M9807A-02

Information Only Service Note

M9807A PXIe Vector Network Analyzer

False alarm on self-test failure on firmware revision of A.13.40.02 - DDR3 memory removal

Self-test

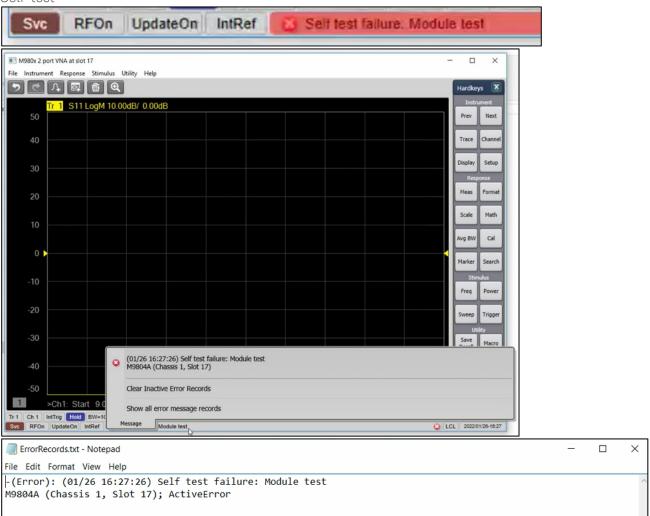
The on board DDR 3 memory in VNA is not in use since its release. With the removal of DDR 3 memory IC on newer M980xA VNA, right after firmware is launched, false alarm (self-test failure) will be reported as shown. This has no impact to VNA performance and specifications.

Similarly, firmware will report a false failure in Operator check. Shown are the error messages example on VNA firmware UI.

Since this DDR3 memory is not in use, newer firmware revision no longer consider it as the failure. Keysight recommends keeping VNA firmware up-to-date whenever it is possible.

For users with firmware revision of A.13.40.02, Update firmware to revision A.13.70.02 or newer to resolve this false alarm on self-test.
